Re: Addendum #1 – UNC Charlotte – Kenndy Hall Roof Replacement
SCO ID # 25-30579-01A

This addendum shall become part of the bidding package for Kenndy Hall Roof Replacement
SCO ID# 25-30579-01A

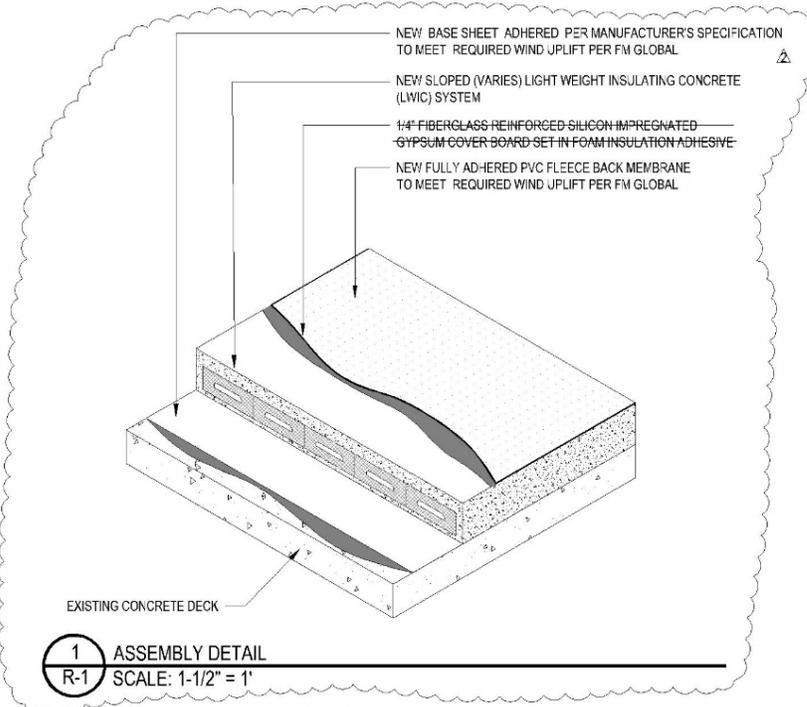
- In Section 01 31 19 PROJECT MEETINGS, replace sentence A with sentence B.
 - The Engineer will schedule and shall conduct in coordination with the Owner's Representative progress meetings at the Project site **once a month**.
Change to
 - The Engineer will schedule and shall conduct in coordination with the Owner's Representative progress meetings at the Project site **once a week**.
- Replace Section 001116, Notices to Bidders with the attached Notices to Bidders.
- Drawings - sheet R-3, 4/R-3 Through Edge Scupper Detail, the opening is 16" wide.

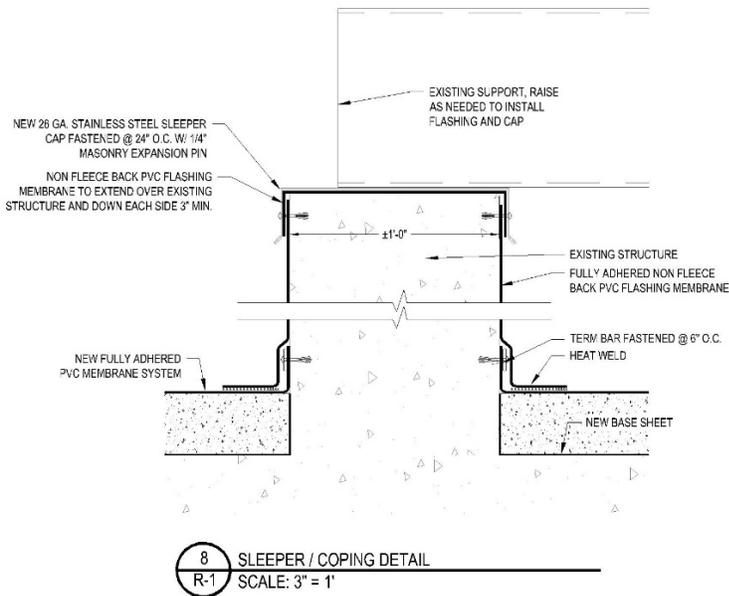
5. 1/4" fiberglass reinforced silicon impregnated gypsum cover board will not be installed over the light weight concrete.
